Menlo Park City School District

Form 470 # 260012641
RFP No. 2026-3002

MPCSD Districtwide Fiber and Laurel Lower Cabling Replacement
Addendum No. 1

Date: February 2, 2026

Appendix A - Laurel Lower Campus Data Closet Map

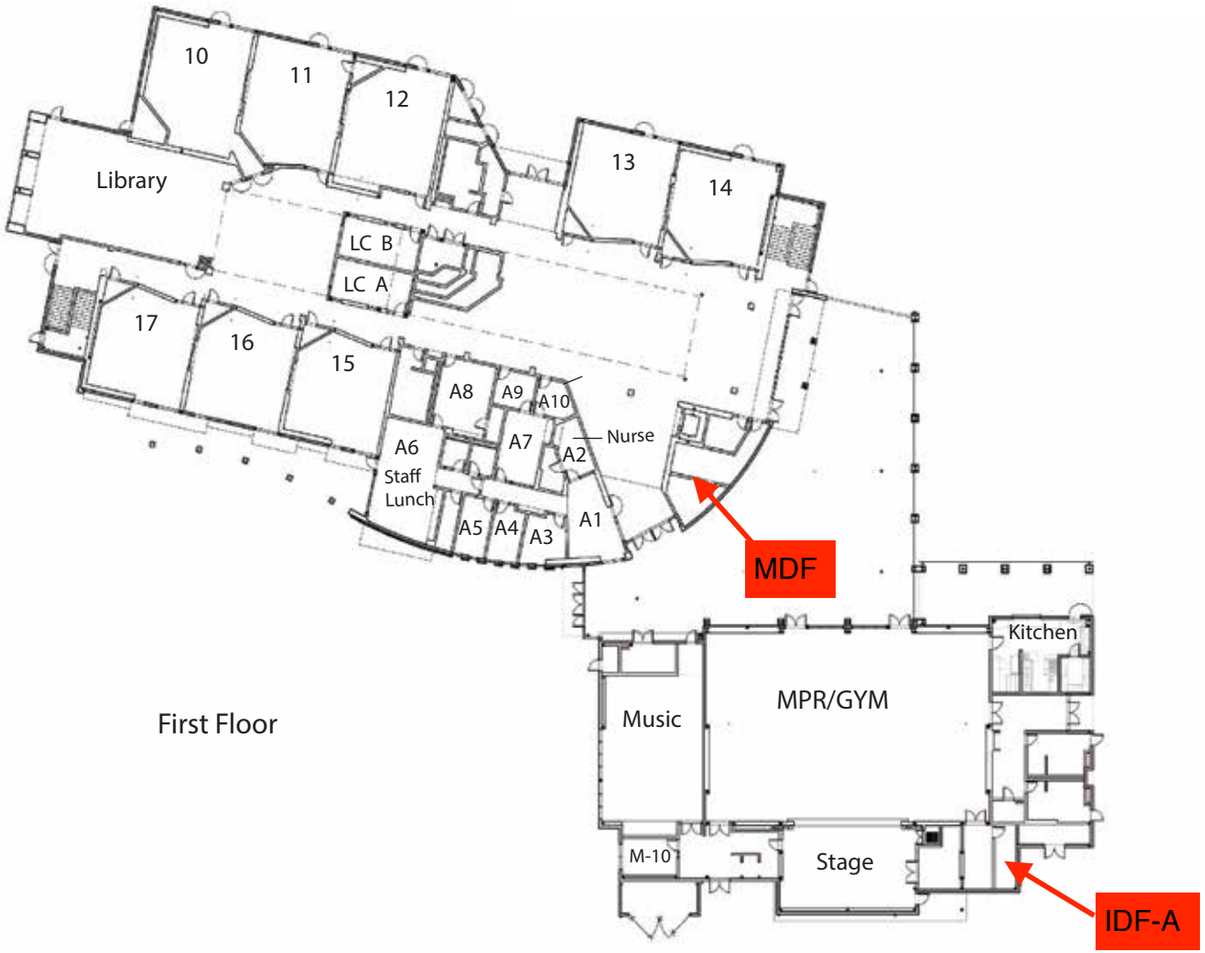
Q. If a lift is needed to reach the ceiling in any room, who will be responsible for providing this equipment?
A. The district will supply a scissor lift when needed, such as in room E3 at Laurel Lower Campus. The vendor is responsible for providing their own ladders.

Q. At the Laurel Lower campus, is the district planning on keeping the existing, silver/metallic wall plates, and should the new wall plates match these in the classrooms and pod space?
A. The bid should include new wall plates and terminations; they do not need to be silver or metallic. They should, however, be consistent across the site.

Q. For the cabling replacement portion of the project, do we need to install additional 2 data drops in the ceiling at the Pod spaces at Laurel Lower Campus?
A. Yes, as per the RFP requirements, each central space in the Laurel Lower pods needs to have at least 2 ceiling drops to support access points and A/V systems.
